# **WORKING GROUP REPORT**

## ***Power Park Modules and Synchronous Generating Units Working Group***

**Prepared by the Power Park Modules and  
Synchronous Generating Units Working Group  
for submission to the Grid Code Review Panel**

Reference	PPMSGUWG Report
Issue	1.0
Date of Issue	9 <sup>th</sup> November 2006
Prepared by	PPMSGUWG

Figure CC.A.7.2.2b

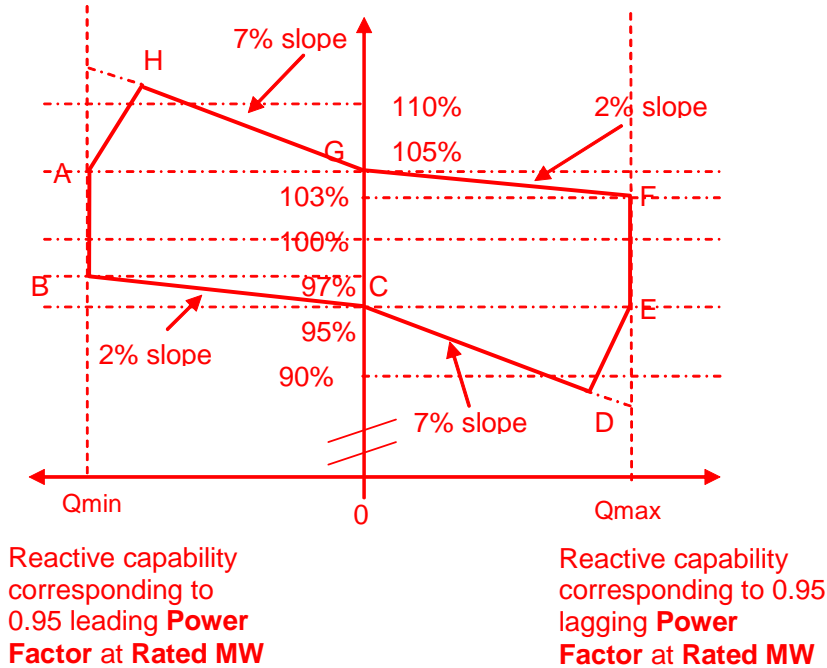
- CC.A.7.2.2.4 Figure CC.A.7.2.2b shows the required envelope of operation. The enclosed area within points ABCDEFGH is the required capability range of the **Non-Synchronous Generating Unit, DC Converter or Power Park Module** within which the **Slope** and **Setpoint Voltage** can be changed.

- CC.A.7.2.2.6 Should the **Reactive Power** output of the **Non-Synchronous Generating Unit, DC Converter or Power Park Module** reach its maximum lagging limit at a **Grid Entry Point voltage (or User System Entry Point voltage if Embedded)** above 95%, the **Non-Synchronous Generating Unit, DC Converter or Power Park Module** shall maintain maximum lagging **Reactive Power** output for voltage reductions down to 95%. This requirement is indicated by the line EF in figure CC.A.7.2.2b. Should the **Reactive Power** output of the **Non-Synchronous Generating Unit, DC Converter or Power Park Module** reach its maximum leading limit at a **Grid Entry Point voltage (or User System Entry Point voltage if Embedded)** below 105%, the **Non-Synchronous Generating Unit, DC Converter or Power Park Module** shall maintain maximum leading **Reactive Power** output for voltage increases up to 105%. This requirement is indicated by the line AB in figure CC.A.7.2.2b.

from the supply of maximum lagging reactive current whilst ensuring the current remains within design operating limits. An example of the capability is shown by the line DE in figure CC.A.7.2.2b. For **Grid Entry Point** voltages (or **User System Entry Point** voltages if **Embedded**) above 105%, the leading **Reactive Power** capability of the **Non-Synchronous Generating Unit, DC Converter or Power Park Module** should be that which results from the supply of maximum leading reactive current whilst ensuring the current remains within design operating limits. An example of the capability is shown by the line AH in figure CC.A.7.2.2b. Should the **Reactive Power** output of the **Non-Synchronous Generating Unit, DC Converter or Power Park Module** reach its maximum lagging limit at a **Grid Entry Point** voltage (or **User System Entry Point** voltage if **Embedded**) below 95%, the **Non-Synchronous Generating Unit, DC Converter or Power Park Module** shall maintain maximum lagging reactive current output for further voltage decreases. Should the **Reactive Power** output of the **Non-Synchronous Generating Unit, DC Converter or Power Park Module** reach its maximum leading limit at a **Grid Entry Point** voltage (or **User System Entry Point** voltage if **Embedded**) above 105%, the **Non-Synchronous Generating Unit, DC Converter or Power Park Module** shall maintain maximum leading **Reactive Power** output for further voltage increases.

Figure CC.A.3.2 - Interpretation of Primary and Secondary Response Values

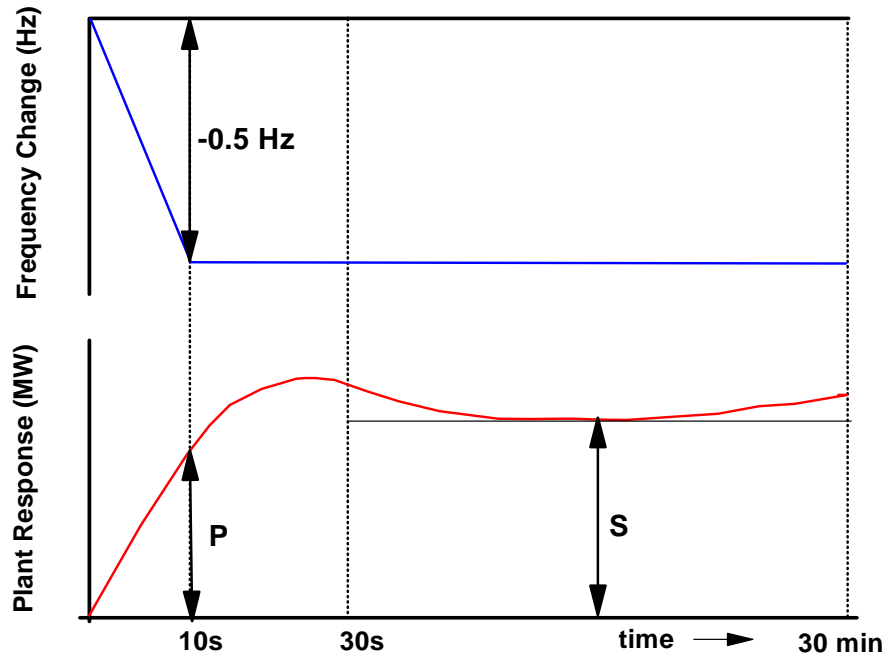
The **Primary Response** capability (P) of a **Generating Unit** or a **CCGT Module** or **Power Park Module** or **DC Converter** is the minimum increase in **Active Power** output between 10 and 30 seconds after the start of the ramp injection as illustrated diagrammatically in Figure CC.A.3.2. This increase in Active Power output should be released increasingly with time over the period 0 to 10 seconds from the time of the start of the Frequency fall as illustrated by the response in Figure CC.A.3.2.

The **Secondary Response** capability (S) of a **Generating Unit** or a **CCGT Module** or **Power Park Module** or **DC Converter** is the minimum increase in **Active Power** output between 30 seconds and 30 minutes after the start of the ramp injection as illustrated diagrammatically in Figure CC.A.3.2.

Figure CC.A.3.3 - Interpretation of High Frequency Response Values

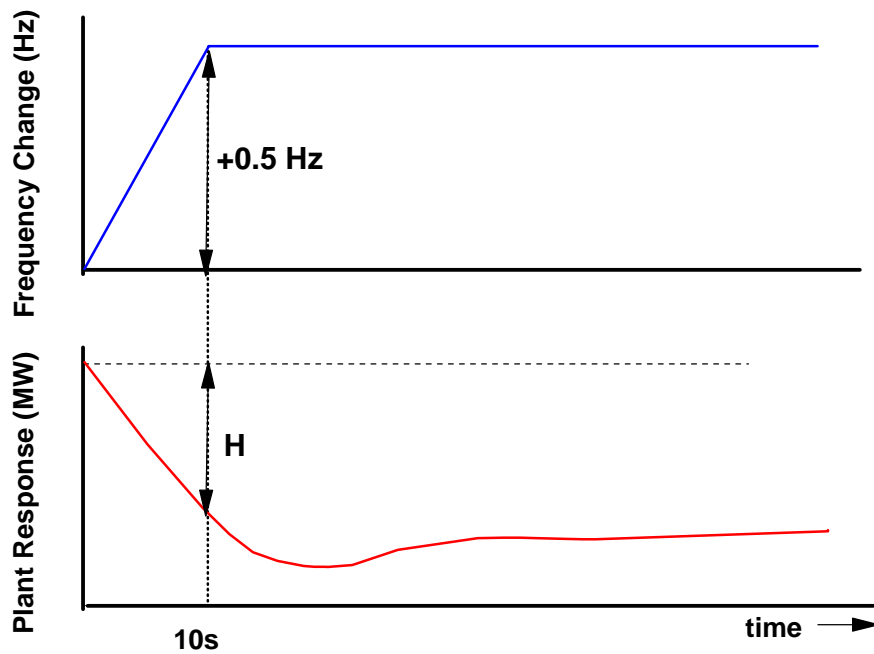
The **High Frequency Response** capability (H) of a **Generating Unit** or a **CCGT Module** or **Power Park Module** or **DC Converter** is the decrease in **Active Power** output provided 10 seconds after the start of the ramp injection and

sustained thereafter as illustrated diagrammatically in Figure CC.A.3.3. This reduction in **Active Power** output should be released increasingly with time over the period 0 to 10 seconds from the time of the start of the **Frequency** rise as illustrated by the response in Figure CC.A.3.2.
